Product Declaration

Applicant: HYUNDAI MOBIS CO.,LTD.
 Product: Car Audio System
 FCC ID: TQ8-ATB31EYAN
 IC No.: 5074A-ATB31EYKN
 Basic Model name: SVM [FCC(ATB31EYAN), IC(ATB31EYKN)]
 Additional Model name: RVM[FCC(ATB30EYAN), IC(ATB30EYKN)]

SVM(Surround View Monitoring System)	RVM(Rear View Monitoring System)

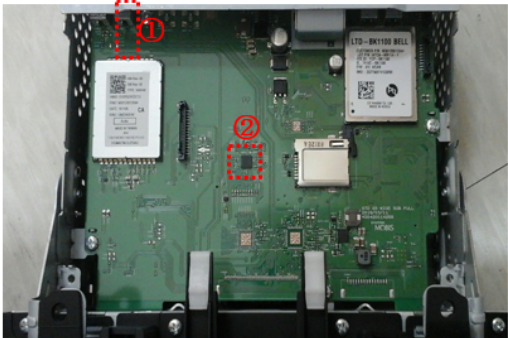
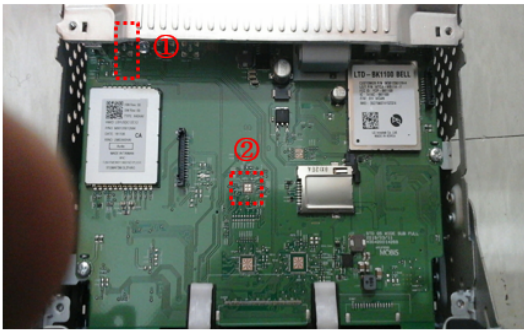
<ol style="list-style-type: none"> 1. Image input connector is inserted 2. Insert LVDS processing IC 	<ol style="list-style-type: none"> 1. Image input connector is deleted 2. Delete LVDS processing IC

* The different parts that including SUB PCB are not affected to RF function.
